Access Compliance Report

Public Rights-of-Way

Intersection ID: 21102	Main Street: S_TRYON_ST	Cross Street: WHITEHALL_PARK_DR	Location: N
ADA ID: 1D6420E97345	Ramp Type: Para	Initial Pass/Fail: Pass	Overall Compliance: No
		Severity Score: 10

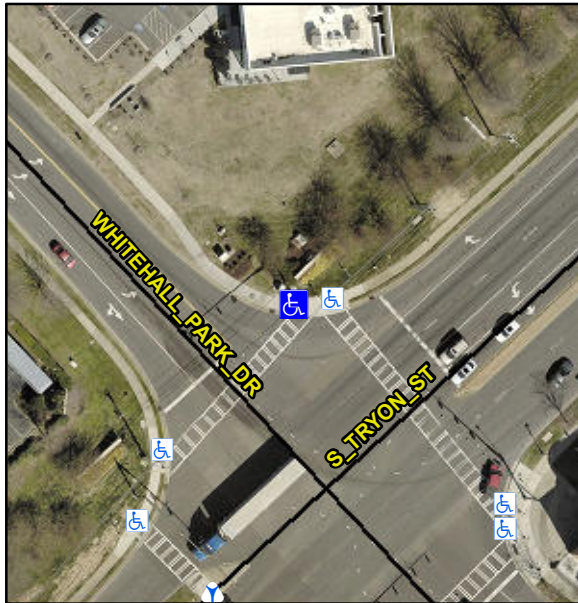
R304.2.1, R304.2.2-Perp, R304.3.2-Para, R304.5.3, R305.2

Compliance	Description	Data	Compliance	Description	Data
N/A	Ramp Length LT (in)	60.0	N/A	Ramp Length RT (in)	61.0
Yes	Ramp Width LT (in)	73.0	Yes	Ramp Width RT (in)	89.0
Yes	Ramp Slope LT (%)	7.4	Yes	Ramp Slope RT (%)	7.4
Yes	Ramp XSlope LT (%)	1.8	Yes	Ramp XSlope RT (%)	1.1
No	Landing Length (in)	N/A	Yes	DWS Provided?	Yes
No	Landing Width (in)	N/A	Yes	DWS Contrast?	Yes
No	Landing Slope (%)	N/A	Yes	DWS Length (in)	24.0
No	Landing X Slope (%)	N/A	Yes	DWS Full Width?	Yes
N/A	Landing Curb? (Y/N)	No	No	DWS Offset (in)	3.5
N/A	Shared Landing?	No			
Yes	Gutter Ponding?	No	Yes	Gutter Slope (%)	1.0
Yes	Gutter Lip Ht (in)	0.0	Yes	Gutter X Slope (%)	0.2
N/A	Painted X Walk1?	Yes	N/A	Painted X Walk2?	N/A
	X Walk 1 Direction	To SW		X Walk 2 Direction	N/A
N/A	X Walk 1 Width (in)	98.0	N/A	X Walk 2 Width (in)	N/A
	X Walk 1 Slope (%)	3.4		X Walk 2 Slope (%)	N/A
	X Walk 1 X Slope (%)	3.0		X Walk 2 X Slope (%)	N/A
Yes	Ramp inside XWalk1?	Yes	N/A	Ramp inside XWalk2?	N/A

Remove & Replace Entire Ramp.
